MEMORANDUM

DATE: December 16, 2008
TO: Christopher Prucha (WM)
C.C.:
FROM: François Richard (WESA)
PROJECT #: K-B5691-6
SUBJECT: **WM Richmond Landfill: Groundwater Flow in the Zone 3-10 m below Top of Bedrock**

**Figure 1:
Groundwater Elevations in 3-10 m below bedrock zone
October 2008**

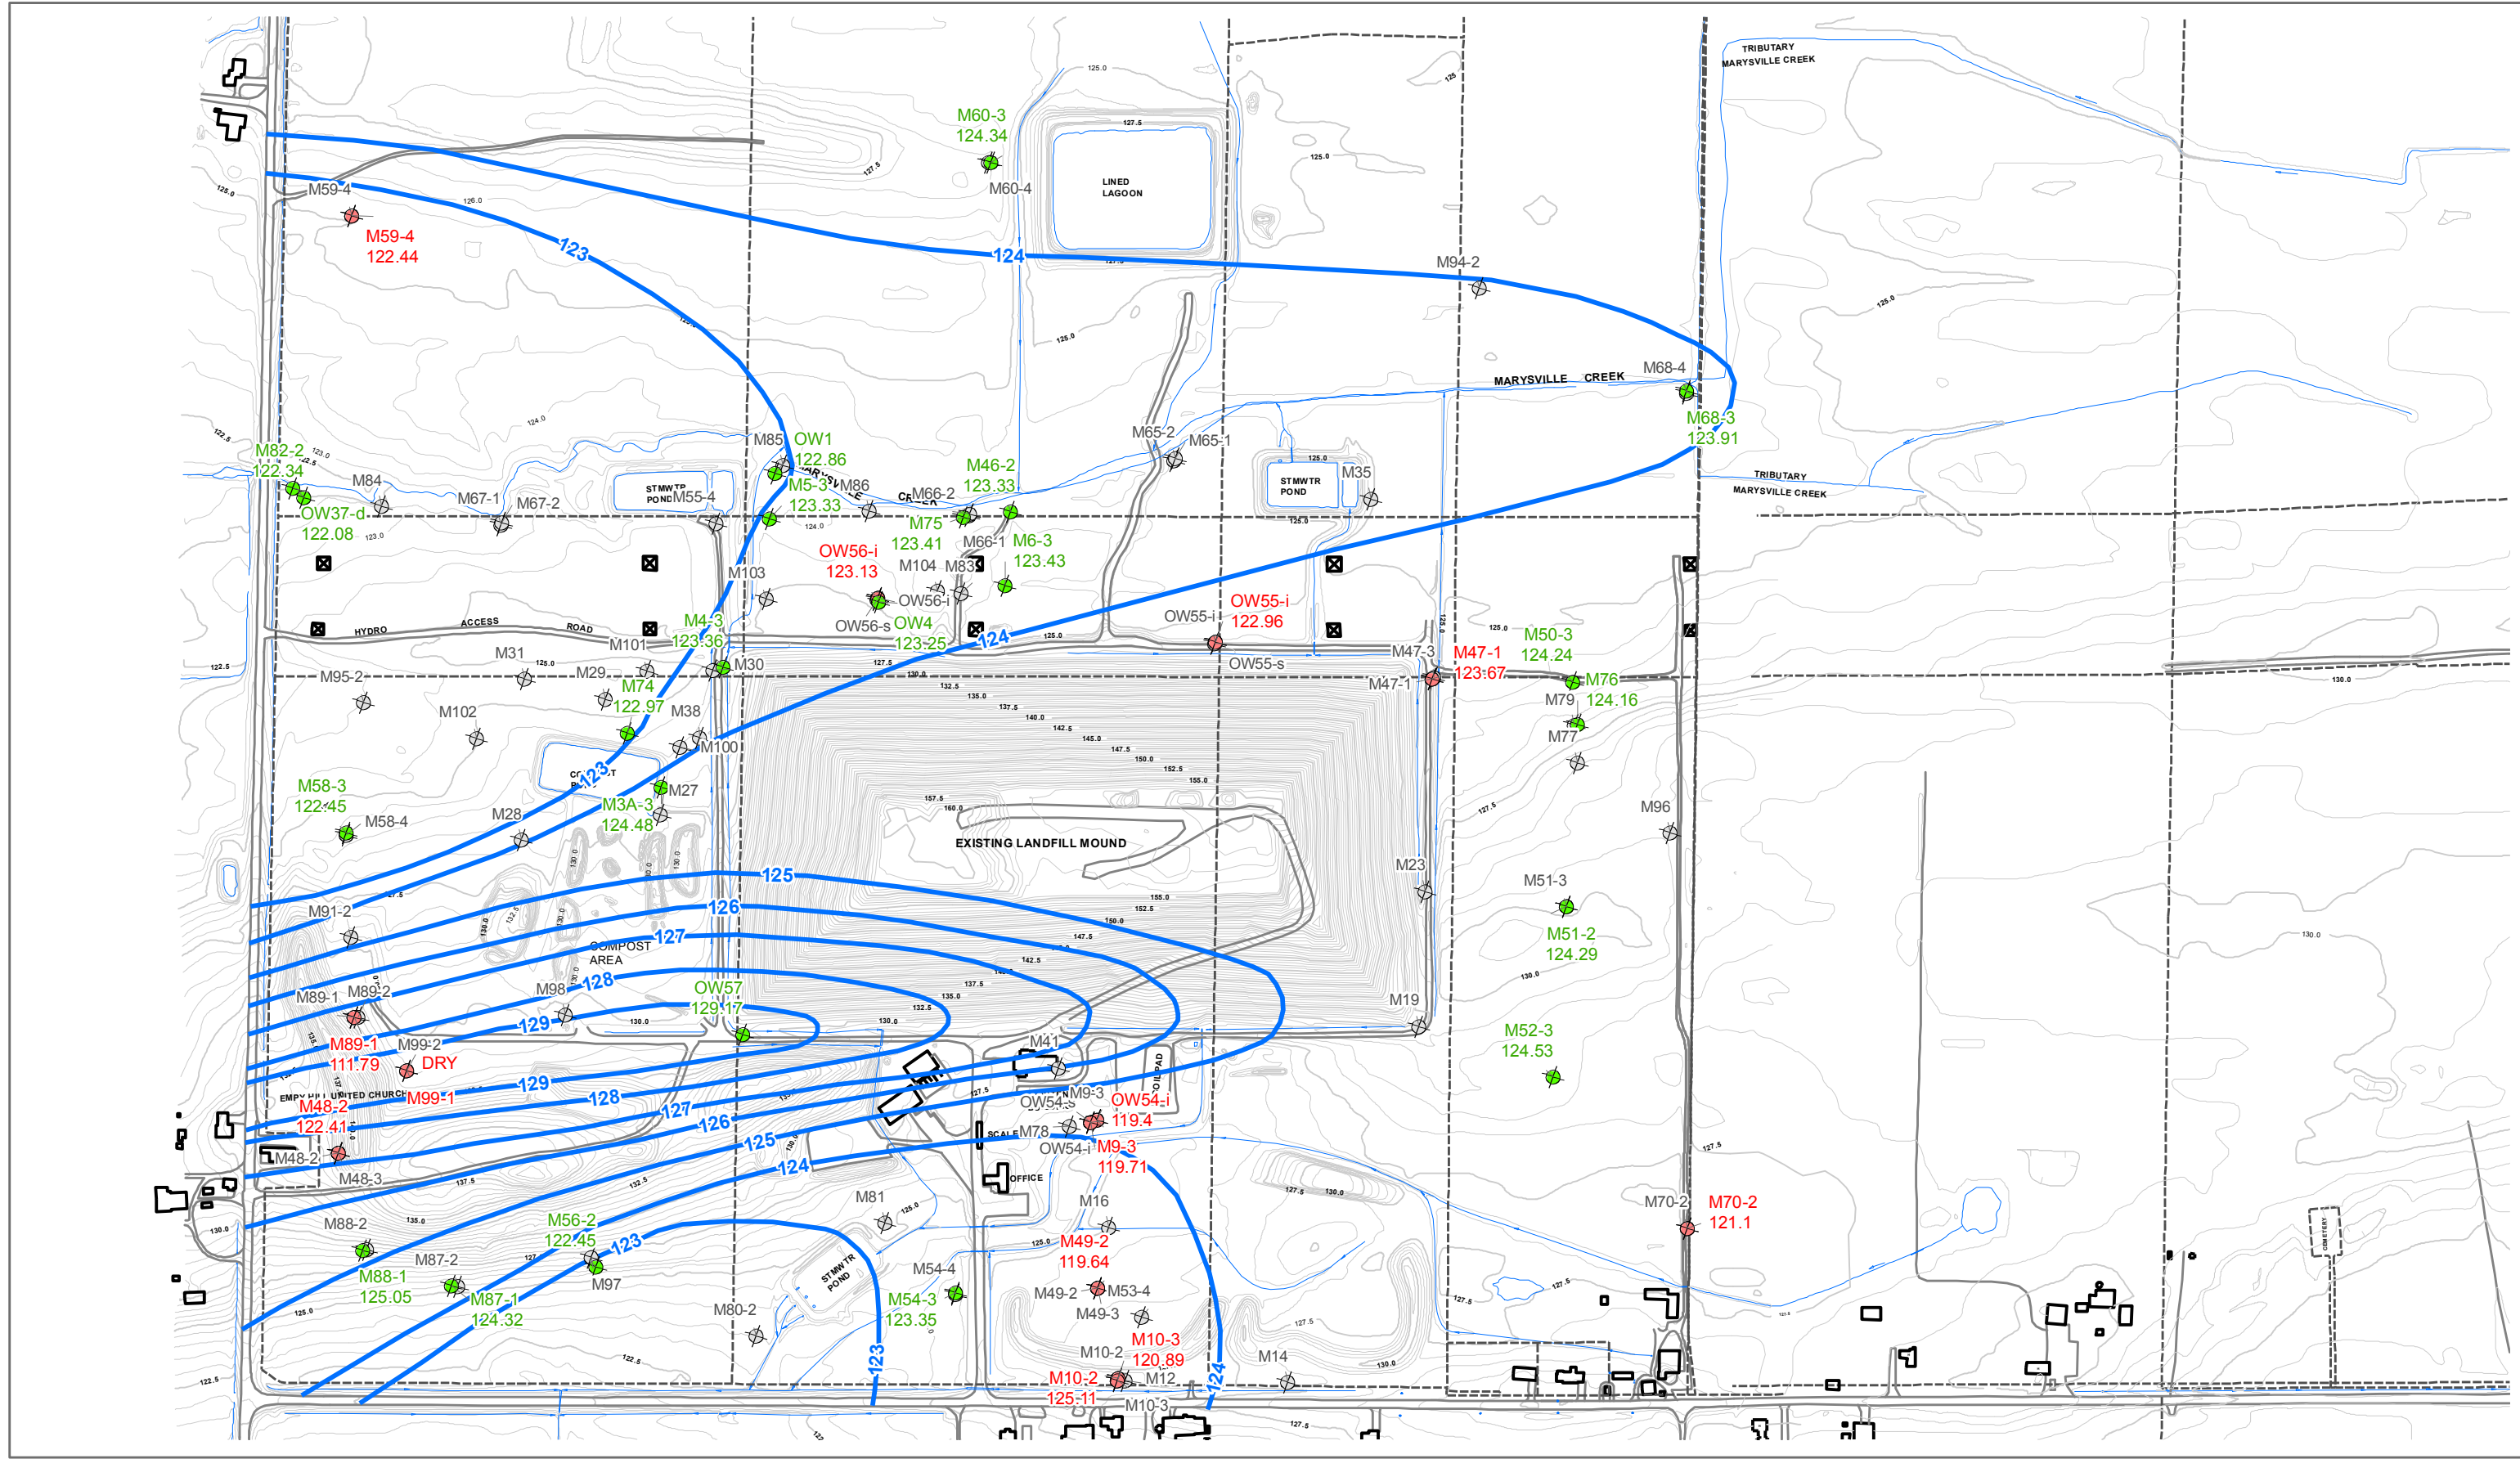
This memorandum addresses questions raised by MOE hydrogeologists Kyle Stephenson and Frank Crossley during our meeting held in Kingston on November 25, 2008. During the meeting, the site conceptual hydrogeologic model was discussed, including the rationale used to identify groundwater monitors representative of the active flow regime and therefore suitable for contouring. It was agreed that the primary pathway for groundwater flow and potential leachate migration is comprised of the saturated overburden and upper bedrock.

However, the MOE noted that most of the monitors retained for the contouring and interpretation of shallow groundwater flow direction are screened in overburden and/or in the upper 3 metres below bedrock surface (mbBR). Concerns were raised about water levels and groundwater flow directions in the portion of the bedrock immediately underlying this shallowest hydrostratigraphic unit, that is, groundwater flow in the zone 3-10 mbBR. Specifically, discussion focused on the hydraulic connectivity between this zone and the shallowest zone, and whether the groundwater flow direction is consistent between these two zones.

Figure 1 identifies the monitors screened in the 3-10 mbBR zone, along with groundwater elevations measured on October 14, 2008. Monitors suitable for contouring are shown in green, while monitors not suitable for contouring are shown in red. Suitable water levels were

contoured, and confirm that water levels in the 3-10 mbBR hydrostratigraphic unit are consistent with previous interpretations presented of shallow groundwater flow directions, most recently in a figure presented during the meeting (October 2008 groundwater elevations and contours), and previously in WESA (2008)¹ for groundwater elevations measured on June 27, 2008. In particular, the groundwater divide running approximately parallel to the Empey Hill drumlin has an influence on groundwater flow directions down in the 3-10 mbBR interval. Note that monitoring wells M6-3, OW1 (both located to the north of the landfill) and OW57 (located at the southwest corner of the landfill), have historically been used in the contouring for the uppermost hydrostratigraphic unit; they are also used in the contouring of the 3-10 mbBR unit since they are screened in this zone.

Based on the information above, it can be concluded that the saturated overburden and the upper 10 mbBR behave as a single monitorable hydrostratigraphic unit. The interpreted shallow groundwater flow directions show minimal differences in the 3-10 mbBR zone compared to the shallower zone. It is therefore appropriate to use groundwater monitors screened in the overburden and/or in the upper 10 metres below the bedrock surface to characterize shallow groundwater flow at the Richmond Landfill.
